Massachusetts Military Reservation

PLUME RESPONSE PROGRAM

Final FS-28 Time Critical Action Memorandum

Appendix A Response to Comments on Draft Action Memo issued May 2, 1997, Response to Comments on the Draft Final Action Memo Issued June 6, 1997, and Memorandum of Resolution for Comments on the Revised Draft Final Action Memo issued July 8, 1997.

SURFACE WATER DECISION TREE

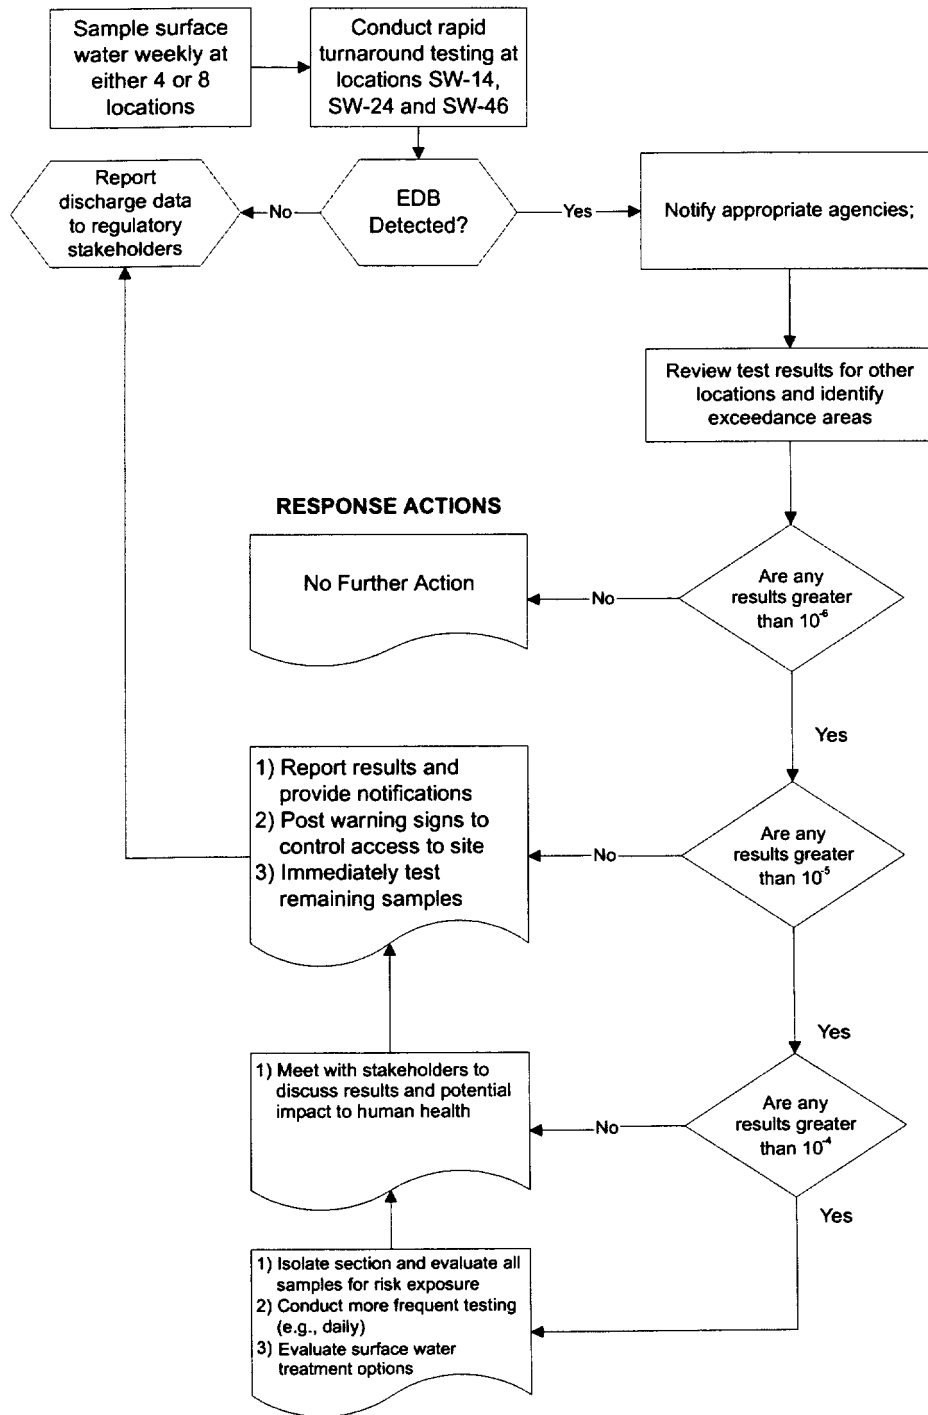
5. Responses to public health concerns must integrate many different types of information (e.g., analytical measurements, citizen concerns, uncertainties, available health data). In contrast to this, the Surface Water Decision Tree (Figure 8) considers only analytical measurements of EDB in surface water and risk equivalents concentrations in the decision-making process. Therefore, we feel that the Surface Water Decision Tree should only play a supporting role for decisions about public health interventions.

FIGURE - 5-5
SCHEDULE FOR PROPOSED ACTIONS
FS-28 ACTION MEMORANDUM

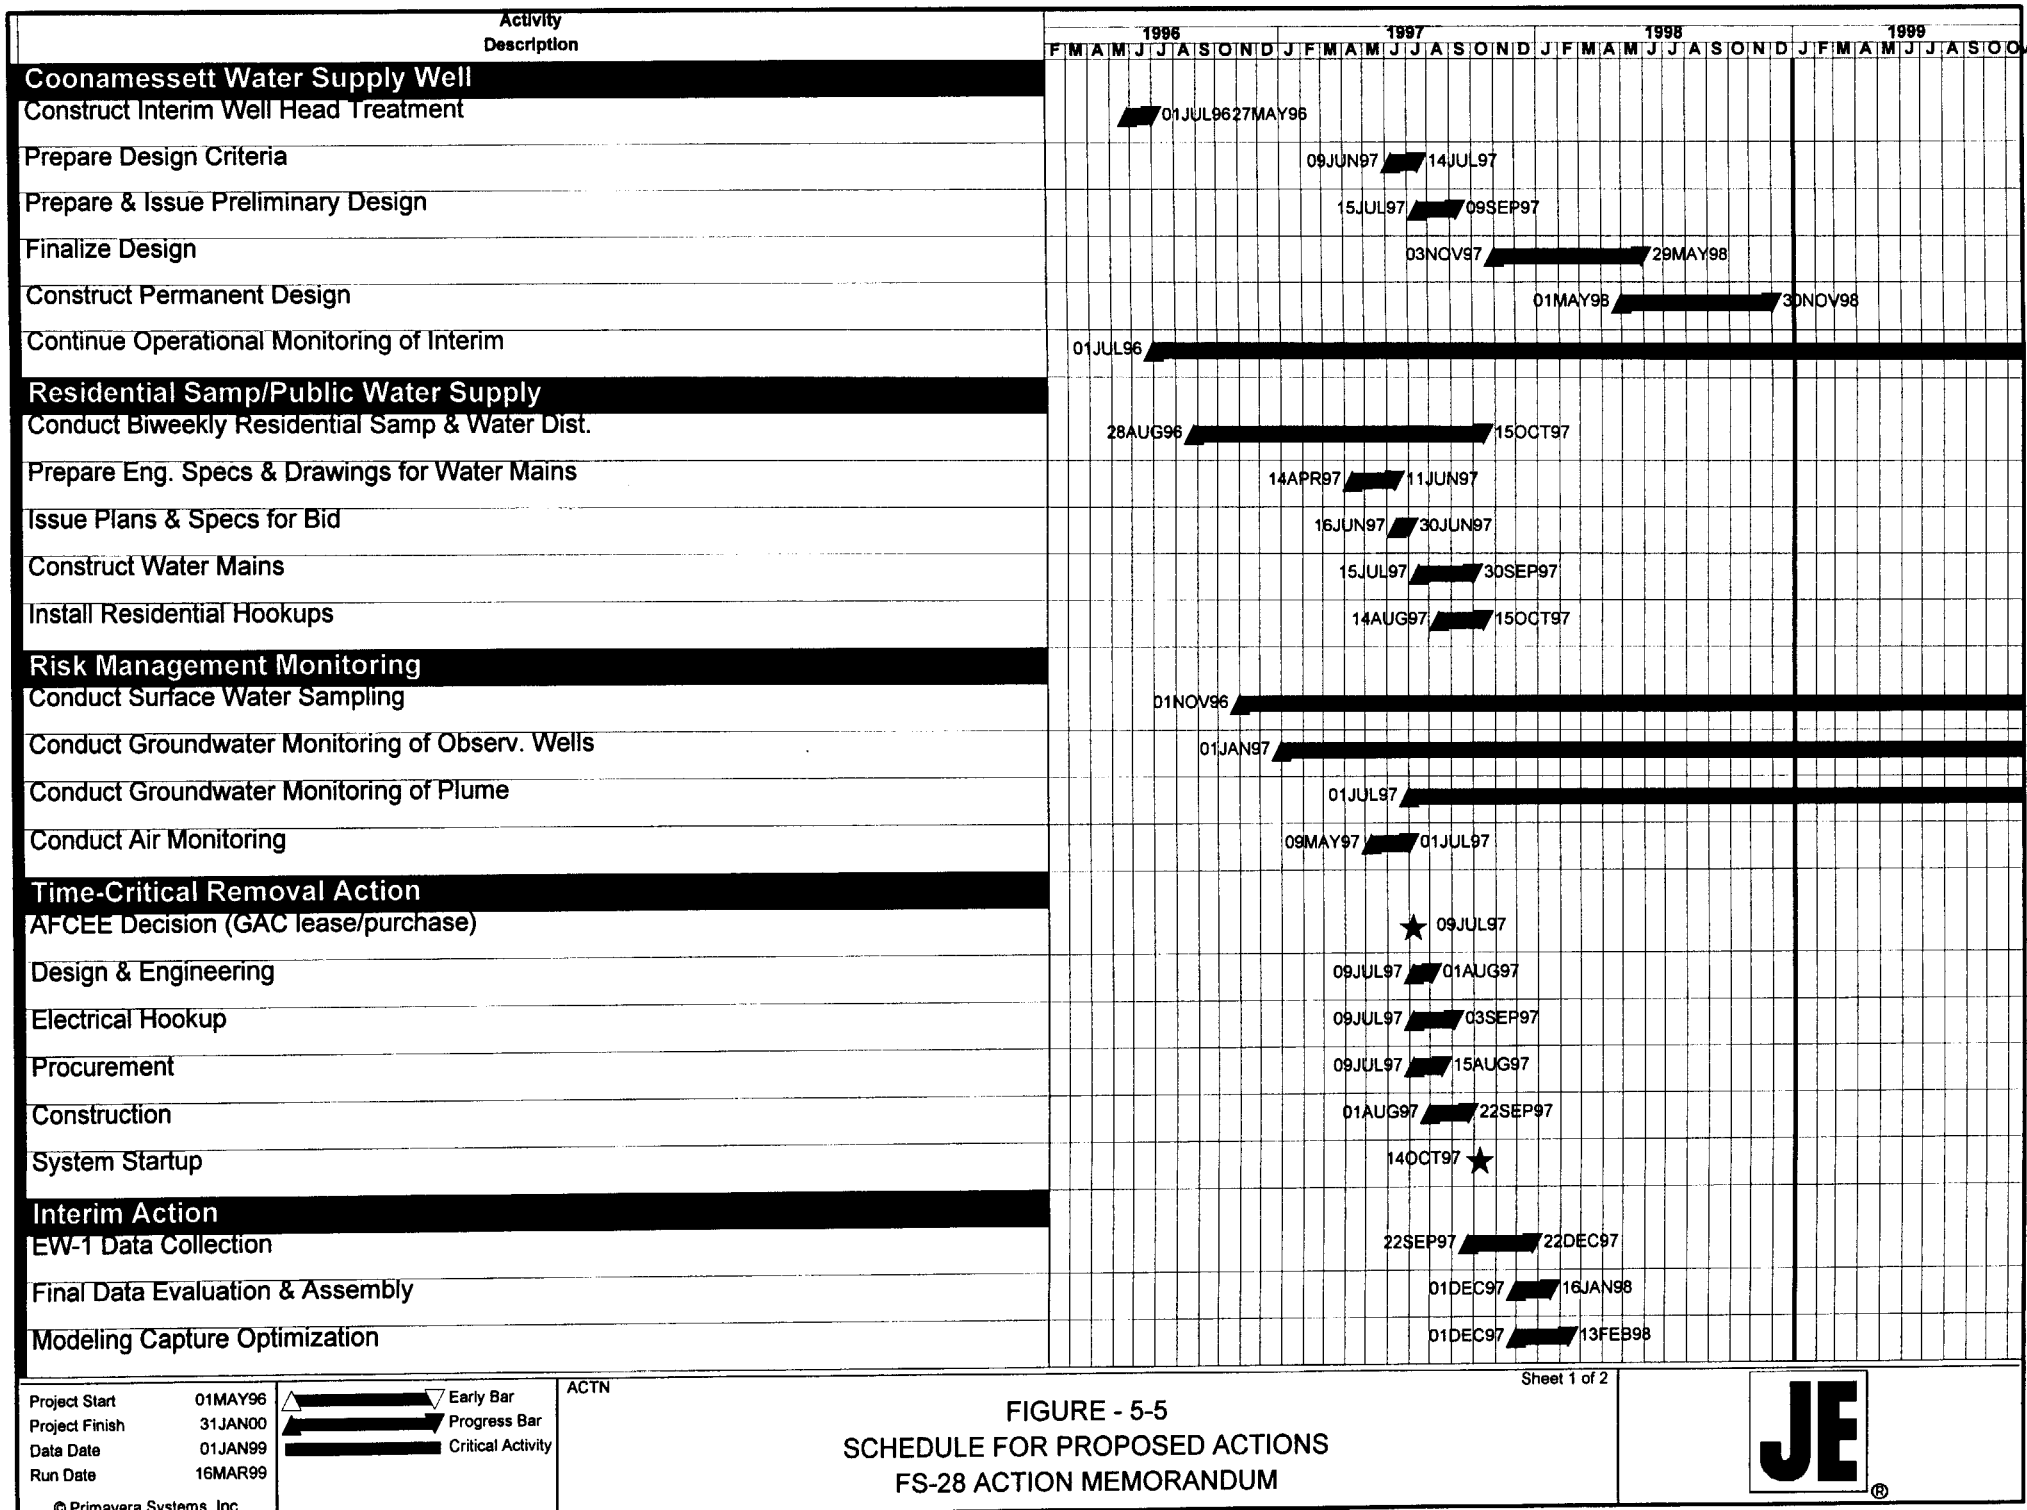
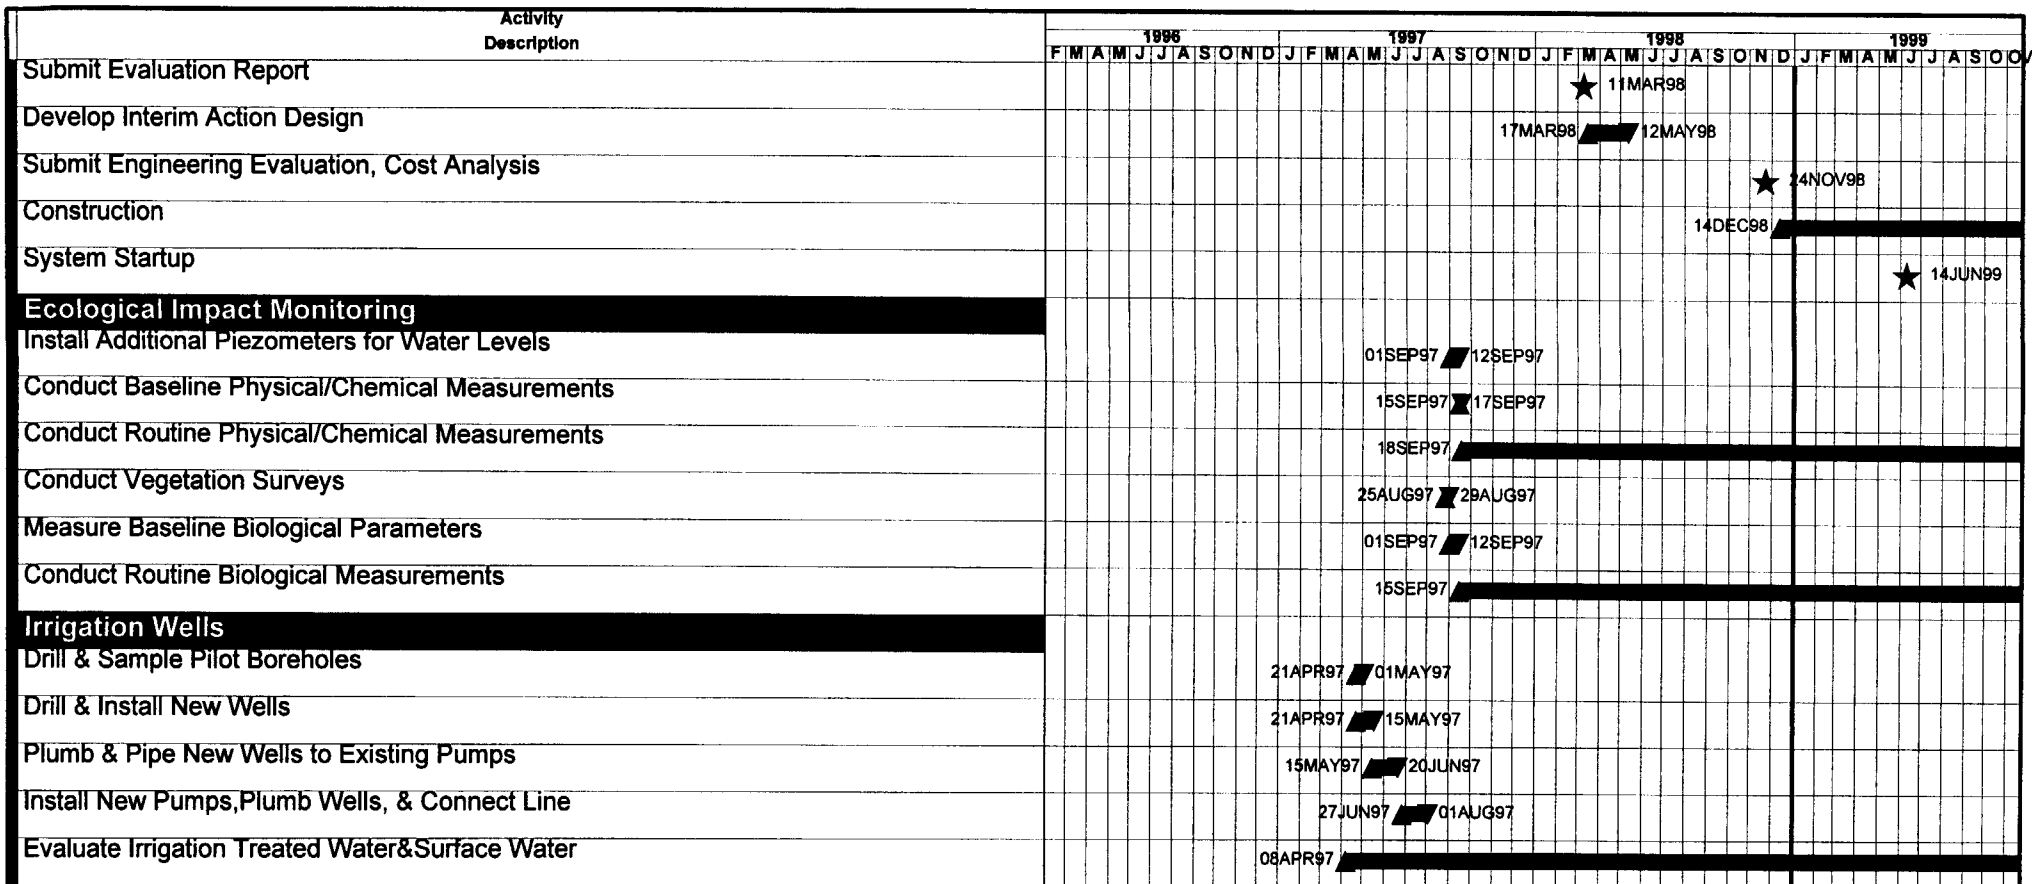
8. **Figure 15:** Please update this schedule to reflect recent agreements for the FFA enforceable schedule for FS-28, Interim Action, and the Southwest Operable Unit (SWOU).

18. Figure 15, Schedule for Proposed Actions. The proposed system startup date of November 16, 1998 for the leading edge interim action is unacceptable. As stated previously, it is imperative that the Air Force have a long-term solution in place to capture and treat the leading edge of the plume prior to next year's fall harvest season which can begin as early as September 1.

19. Figure 15. EPA is proposing that an interim deliverable be added to the schedule for irrigation well operation. Specifically, a document should be submitted in the January/February timeframe which evaluates the influence of the irrigation wells on the plume during the 1997 irrigation/harvest season. It is imprudent to wait until two growing/harvesting seasons have passed to formally evaluate the irrigation wells' influence on the plume. In addition, the schedule for operation of the irrigation wells extends well into October 1998. Please explain.

20. Figure 15. This figure needs to be amended to reflect earlier comments on distinguishing between actions relevant to the time critical removal action and the interim action. Specifically, Figure 15 should be a schedule of removal action activities. Separate figures, e.g. Figure 15A and 15B could be created for interim action and SWOU activities.
